Environmental Impact Report for the Palms Groundwater Recovery Project

State Clearinghouse Number 2020060315

**Buena Vista Water
Storage District**

February 2022

Figure 3-7. Groundwater Elevation Map of the Buena Vista Water Storage District

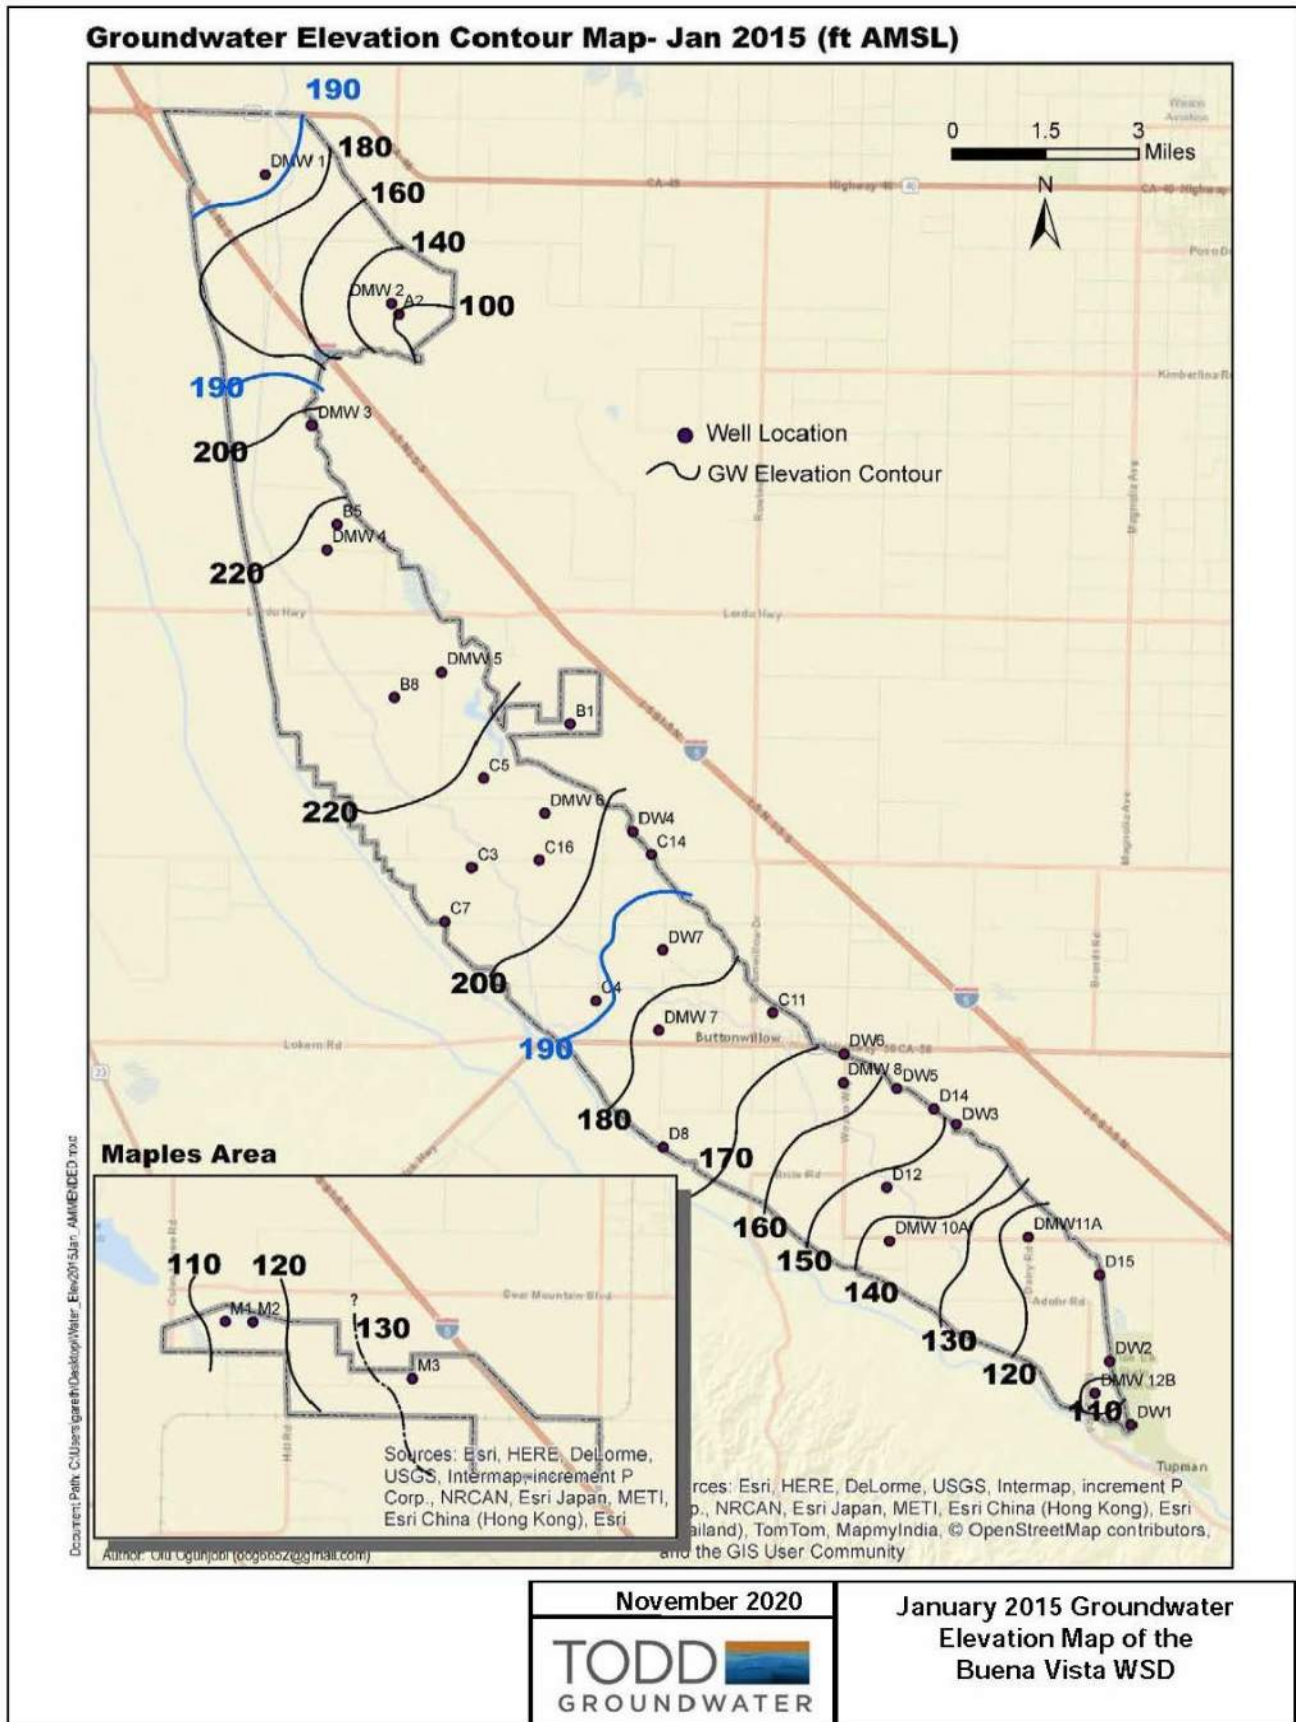
- 8 | 8. The general groundwater flow direction shown on Figure 3-7 of the DEIR appears to be a reasonable interpretation based on regional data. Closer to the proposed project however, in the southern portion of the BVSWD service area, groundwater flow directions are reported to vary in response to recharge and recovery operations by WKWD, the Kern Water Bank, and other factors. Were variable groundwater flow directions considered as part of the analyses? Would groundwater flow directions other than northwest to southeast result in significantly different simulation outcomes?
